REQUEST FOR PROPOSAL

Project Title: Cooley Laboratory Renovation
Location: Montana State University

PPA No.: 10-0023
RFP No.: 107
Date: April 24, 2013

RELOCATE EXISTING DOOR 314a INTO OPENING BETWEEN 005E AND 029

COOLEY • NEW DOOR BETWEEN
005 E & 029

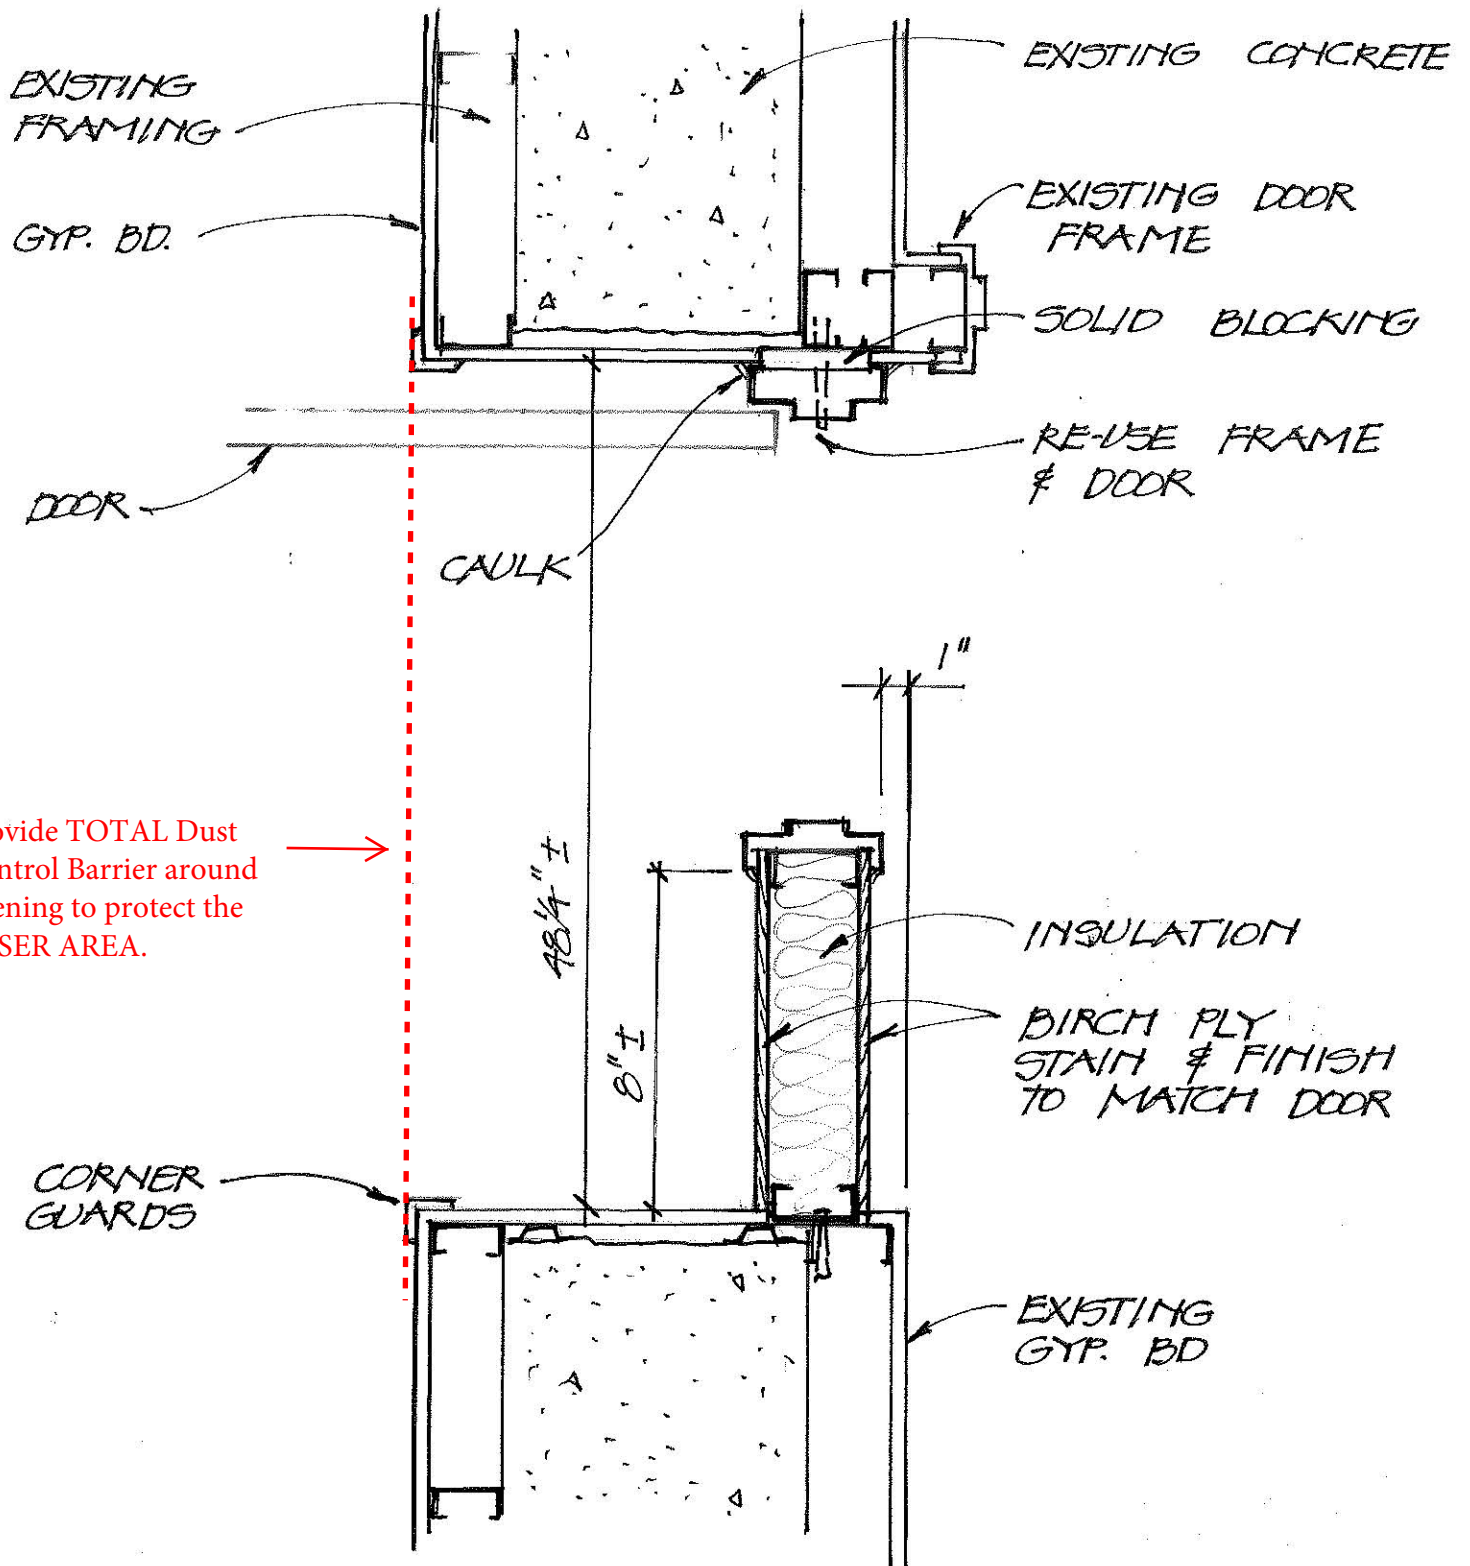
Install Existing Door from 310 into opening between Room 005E and 029.
Area is extremely sensitive to any dust. Provide maximum dust protection while performing ALL phases of work.

- The opening is 48 + inches wide and slightly less than 7'-0" tall.
- The Door will require patching where the closer was attached.
- The door frame will need to be reduced to fit the opening (Lower the head of the door frame)
- Wall infill at the new door location to be metal stud and Birch Plywood to match the door.
- Add Lockset 93K7 D 15D S3 Key side to be Room 029

Provide TOTAL Dust Control Barrier around opening to protect the LASER AREA.
